The X35 Official New Firmware Release Note (R1681)

- ① Release date : June 11th, 2021
- ② The version of updated firmware : R1681
- ③ Refer to the below for the contents updated from R1530 to R1681

1 Complete change of Music DB Structure

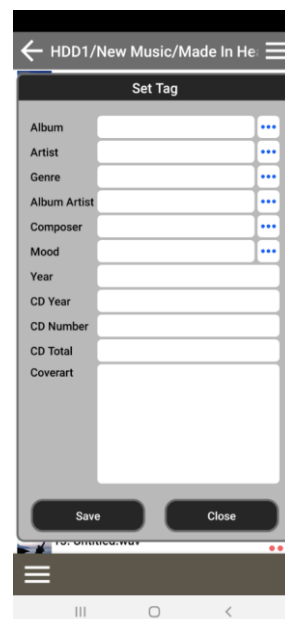
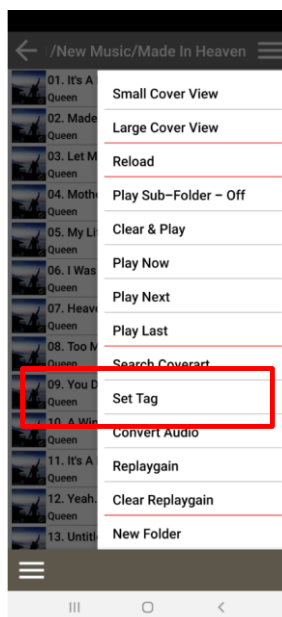
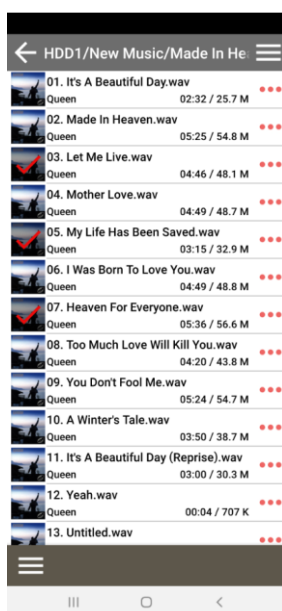
We have changed Music DB structure completely from firmware R16xx. To understand New MusicDB, please read the manual of 'New Music database(MusicDB) Structure for existing models'
